ATTACHMENTS to EXISTING SUBMISSION POINTS

Additional detail to points on visual impact see page 8 and page 10

Additional detail to points on survey discrepancies and alterations, see pp 8/9 and 11

Viewpoint 2 : Extracts from the 2022 photomontage from Bob Campbell Oval , compared with 2019 photomontage form the same location, shows the 2022 building looking smaller, despite GFA increases. REALLY?

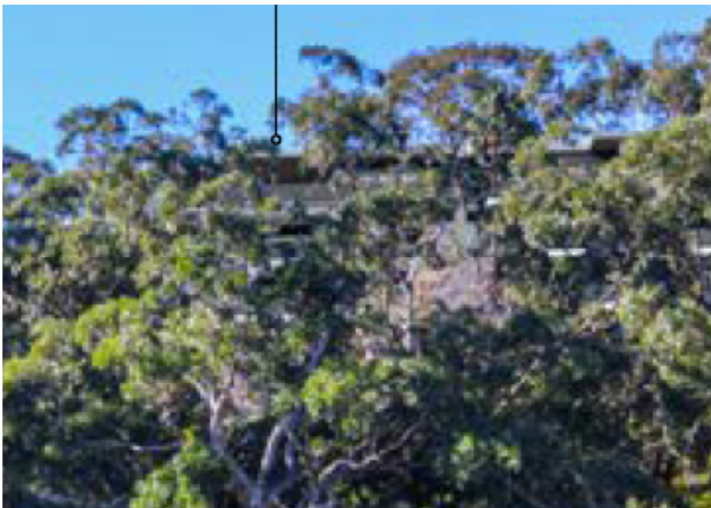
The 2022 version – more GFA, but looks smaller ??

Anticipated View Upon Planting Maturity.

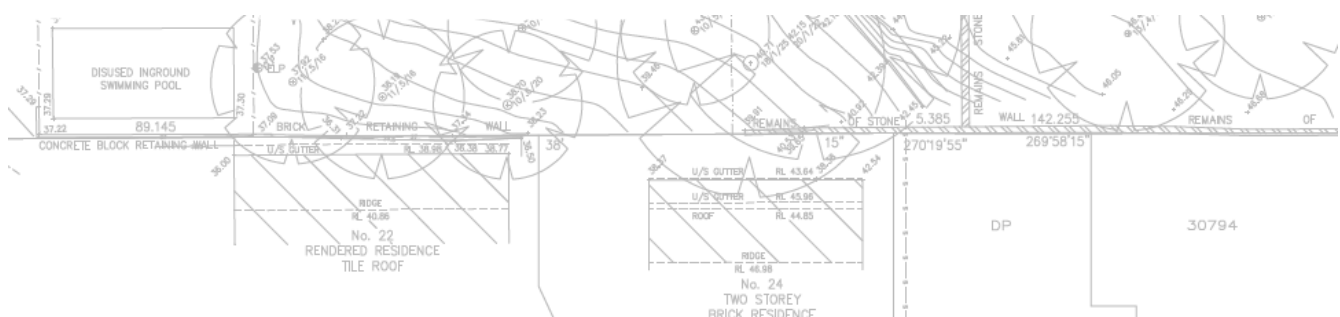
Viewpoint 6: This anticipated view is just as misleading as it was in the 2019 visual impact assessment because it makes the false claim that additional planting when grown to maturity (about 40 years!!) it will obscure the lower portions of the Seniors Buildings.

The Landscape Detail design is now prepared, yet no correction has been made to the text of the notation, see extract below.

Furthermore, the Landscape does not have any planting of such a type to reach this canopy at maturity.

Below: Appendix I 2 Civil Eng. Plan extract at south boundary between adjoining 24 Gore St (wrongly labelled herein as 22 Gore St) and 51 Gore St, Greenwich

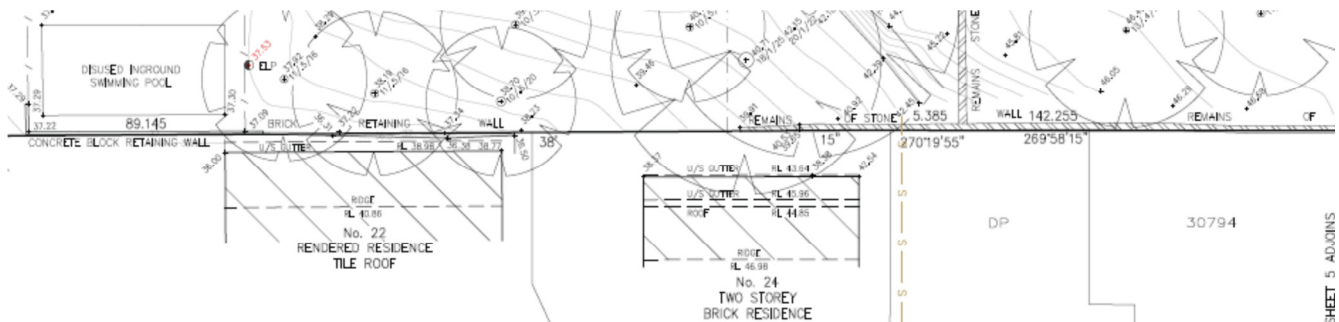
Below: Appendix E Survey—extract at south boundary between adjoining 24 Gore St (wrongly labelled herein as 22 Gore St) and 51 Gore St, Greenwich.

Clearly, the underlying Survey layer is the same in each extract above. The wrong house addresses occur in both extracts which is not a co-incidence because the LTS Survey is used as the underlayer for the Civil Engineering. (No. 22 should read 24, and what is labelled No. 24 should read No. 55). It is a common practice in computer aided drafting (CAD) to use the CAD survey in this way, which has the benefit of reducing discrepancies, The CAD survey file can enable accurate measuring and calculations such as slope or gradient, which is important for hydraulic calculations, pipe sizing and fluid dynamics.

Below : Appendix I 2 Civil Eng. Plan extract at SW b'dy. Below R: Appendix E Survey p.4— extract at SW bound'y

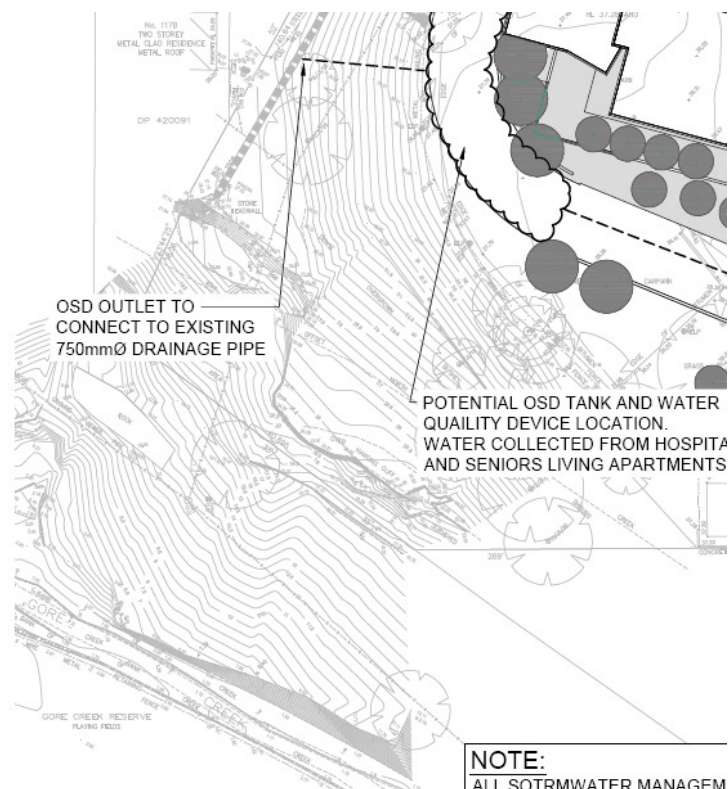
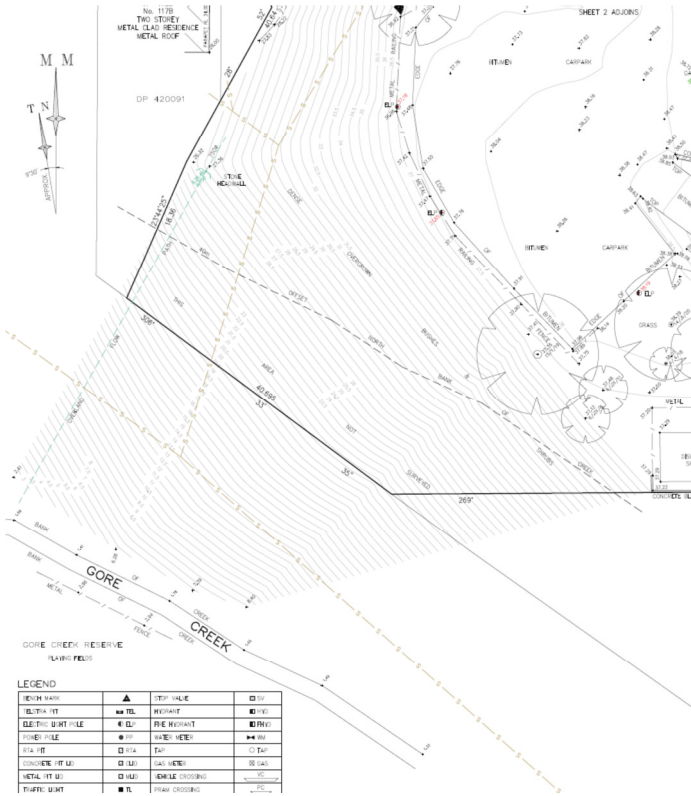
ALTERED CONTOURS are shown on App. E Survey when compared with the accurate topographical information shown on Civil Eng. App. I 2 underlay survey

The south-west bushland slope contours below RL 37 appear very differently on the LTS Survey, than on the Civil Eng. Plan. Starting from contour RL 37 (see it at the SW corner of the disused swimming pool) and continuing downslope to Gore Creek, the CAD layer of contour isolines below RL 37 have been altered. In fact, at the west end of the southern boundary, the survey drawing contour gives the corner elevation as being more than four (4) metres higher than on the Civil Eng. Plan does. CAD software has a “stretch” function, which can aid in the creation of an averaging of isolines between chosen field perimeters.

Below L: Appendix 1 2 Civil Eng. Plan extract at SW bdy.

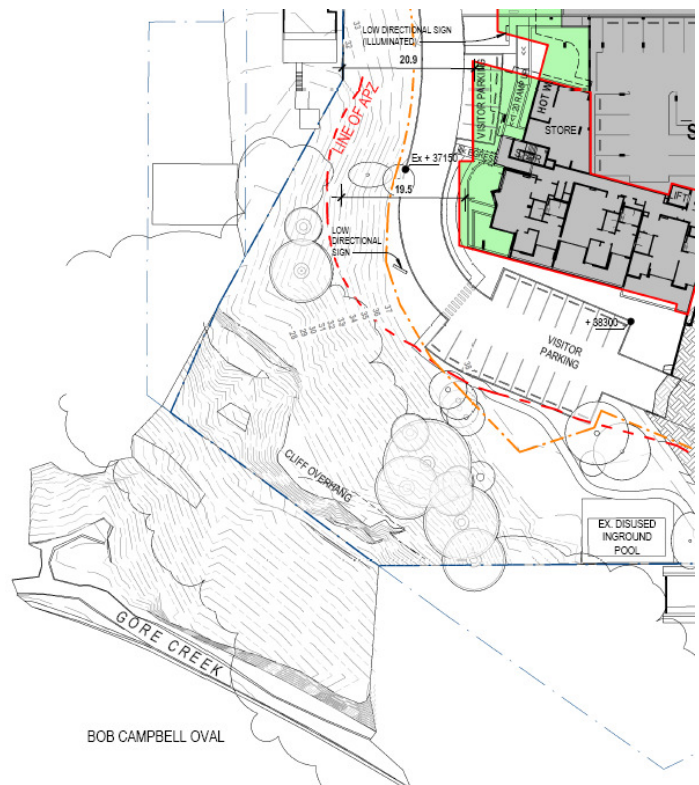
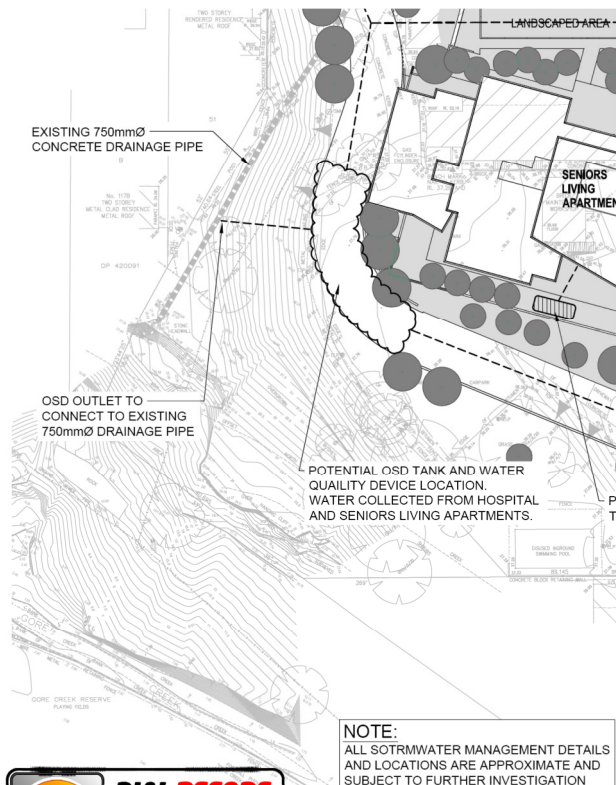
NOTE the underlay words appearing on each extract (such as “dense” and “40m offset north bank creek”) are the same, and in the same places. NOTE The words “this area not surveyed” appear only on the Appendix E Survey.

The correlation between the “new “ “discovery” by the architects and surveyor, of features and survey isolines with what the Civil Engineer showed in 2018 on their survey underlay is so high as to indicate that the south west slope was part of the 2009 survey.

Note in the above left, it seems beyond belief that the detail rock formations, contours, cliffs, tree clusters etc were not known in 2018 (from 2009) by the surveyors. The extract above right, from architectural drawings produced four years later, correlates so exactly and so precisely, with the Civil extract above L. available in 2018, that it is not an accident.

Where there is a difference at top of bushland slope and to the west of disused pool, is result of where Hammondcare have been carrying out works to produce a different “start” scenario. Eg. removal of vegetation, re-contouring and filling (flattening) of the upper area with coir logs, and revegetation ahead of any Landscape plan approval or any comprehensive survey of trees on the bushland slope.

The “invented” or stretched contours have implications which work to Hammondcare’s advantage, such as reducing the calculated downslope for purposes of Planning for Bushfire Protection on bushfire prone land. It has also enabled Hammondcare to make various unsubstantiated claims about the bushland slope.
